Stage 1/2 Road Safety Audit Response Document

Amendment Application to Blocks A and D of GA01
lands at Baldoyle, Co. Dublin

Land Development Agency

Road Safety Audit Stage 1/2

Figure 2.1 – Proposed Tie-in at Railway overbridge

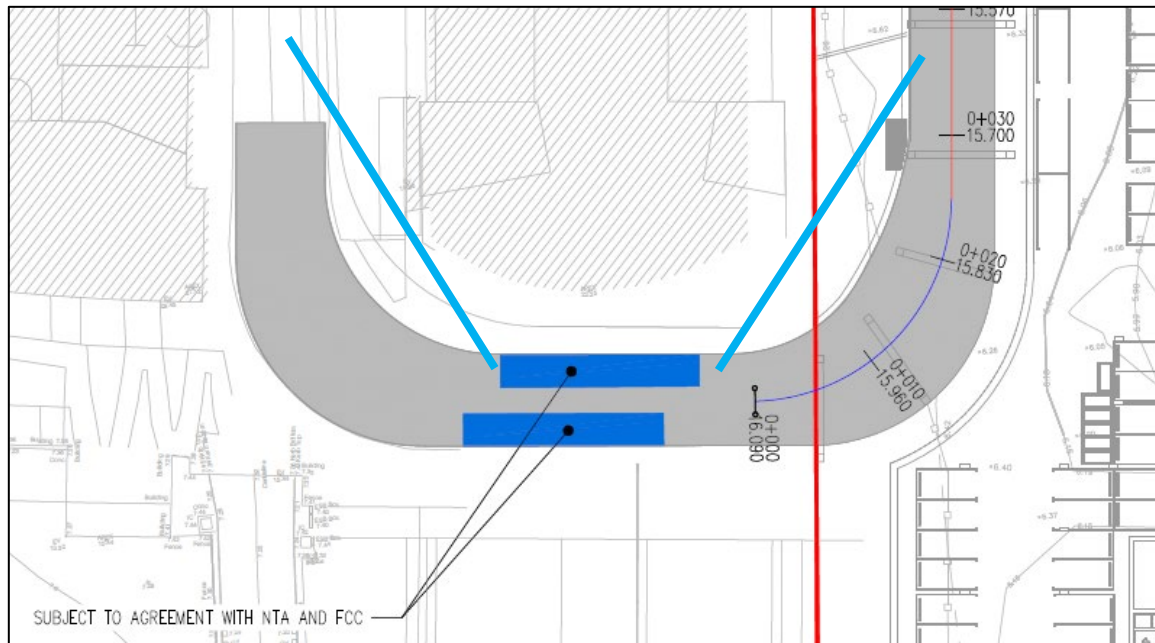
The existing tie-in to the railway overbridge may have resulted in reduced Stopping Sight Distance (SSD). It is unclear whether adequate Stopping Sight Distance will be provided at the proposed tie-in arrangement. Restricted Stopping Sight Distance may prevent drivers from perceiving hazards in sufficient time to stop safely, thereby increasing the risk of rear-end collisions

Recommendation: Ensure adequate Stopping Sight Distance is provided.

Adequate stopping sight distance shall be provided.

Figure 2.4 – Proposed Bus Stops at Existing Railway overbridge

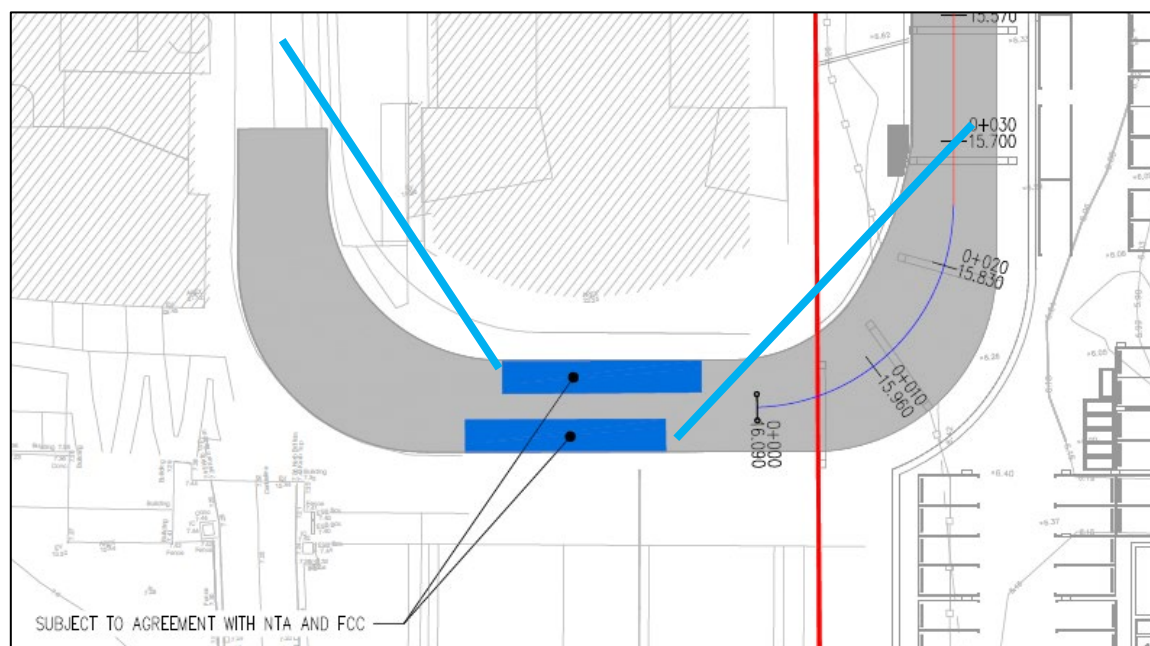
The existing tie-in to the railway overbridge may have resulted in reduced Stopping Sight Distance (SSD). It is unclear whether adequate Stopping Sight Distance will be provided at the proposed tie-in arrangement. Compromised Stopping Sight Distance may be exacerbated by operation of proposed bus stops when occupied by buses, especially for Eastbound traffic. This may result in blind overtaking with an increased risk of head on collisions.

Recommendation: Ensure adequate Stopping Sight Distance to buses stopped. Consider additional traffic calming measures including a central reservation to prevent overtaking.

Adequate stopping sight distance shall be provided. However, the solid road marking indicates that no overtaking is permitted. In addition there is an existing pedestrian crossing point which will warn road users and act as a traffic calming measure.

Figure 2.7 – Proposed Overhanging Trees

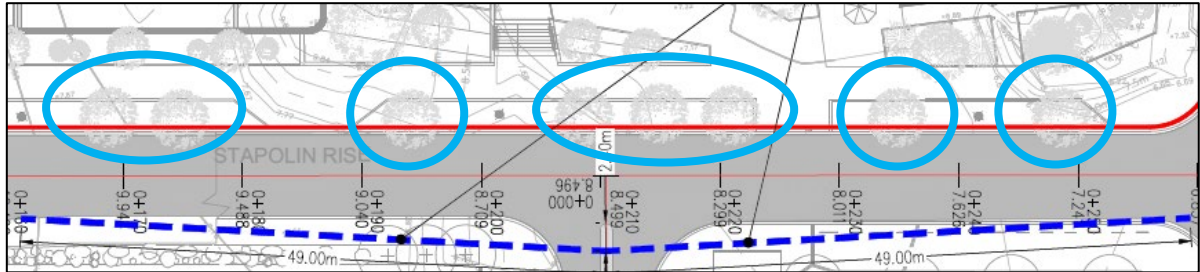
Proposed Trees overhanging on Stapolin Rise may encourage overrunning of the central line, resulting in an increased risk of sideswipe collisions.

Recommendation: Ensure adequate street space for all vehicle movements. Select appropriate trees in conjunction with an Arborist. Ensure adequate maintenance of trees.

Adequate streetscape for all vehicles movements will be provided. Any trees intruding upon said streetscape will be moved as required.

Figure 2.8 – Proposed Sightlines with obstructions - Overhanging Trees

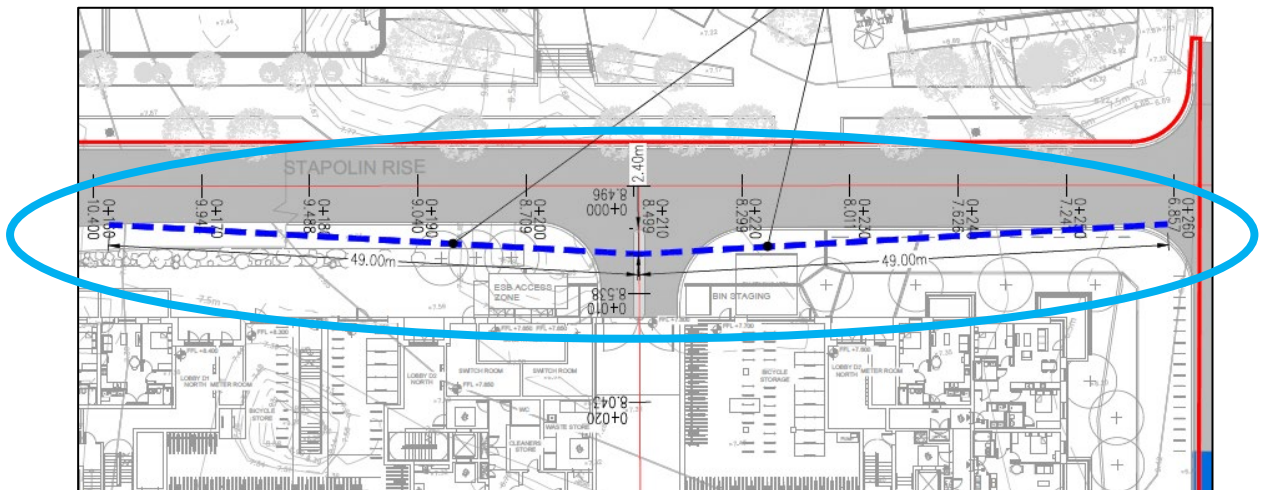
Proposed visibility splays may be obscured by proposed trees, cycle parking and vehicles parked in adjacent parking bays. Compromised visibility splays may result in an increased risk of vehicular collisions.

Recommendation: Ensure all visibility splays are free of obstructions.

Adequate unobstructed sightlines of 49m with a set back of 2.4m can be achieved in both directions in accordance with DMURS.

Figure 2.12 – Pedestrian Desire Lines with no Infrastructure

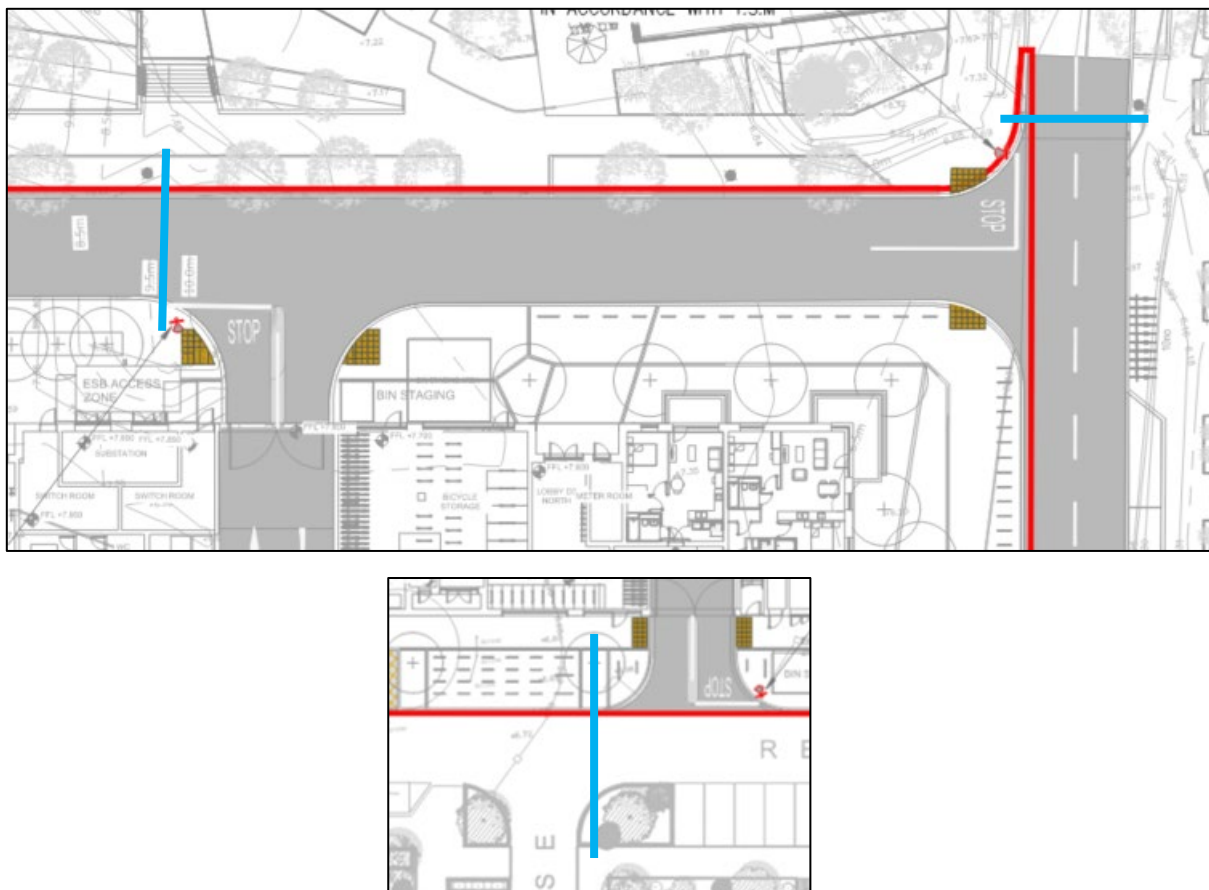
Formal pedestrian crossing points have not been provided along all likely desire lines, which are likely to be frequent due to proximity to the train station. Pedestrians crossing without adequate infrastructure may increase risk of pedestrians being struck by passing vehicles.

Recommendation: Ensure appropriate pedestrian crossing infrastructure at all desire lines.

Appropriate pedestrian desire lines are provided.

Figure 2.13 – Pedestrian Crossings with restricted Intervisibility

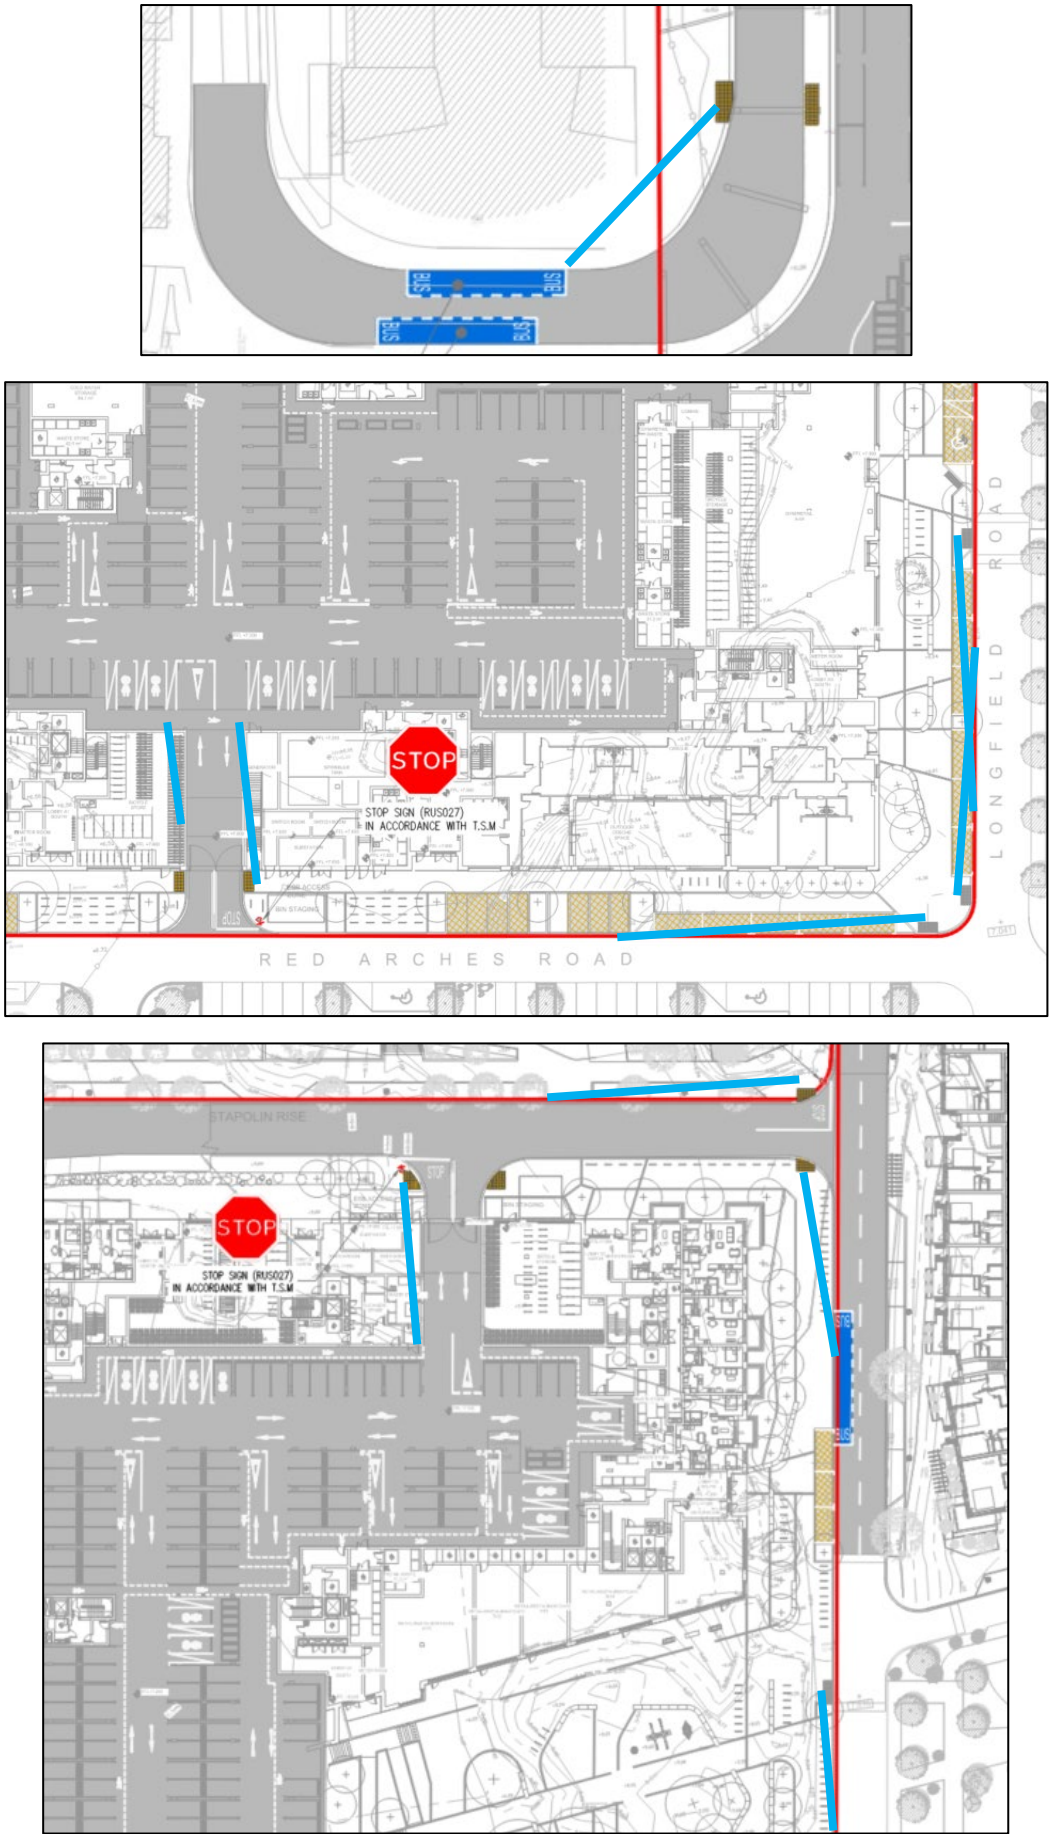
Intervisibility between pedestrians and drivers of vehicles approaching pedestrian crossings may be restricted by planning, cycle parking and cars parked in car parking spaces adjacent to the pedestrian crossing locations. A lack of adequate intervisibility may contribute to pedestrian collisions at the pedestrian crossings.

Recommendation: Ensure adequate intervisibility between pedestrians and motorists is achievable at all pedestrian crossings.

Appropriate pedestrian inter visibility has been provided.
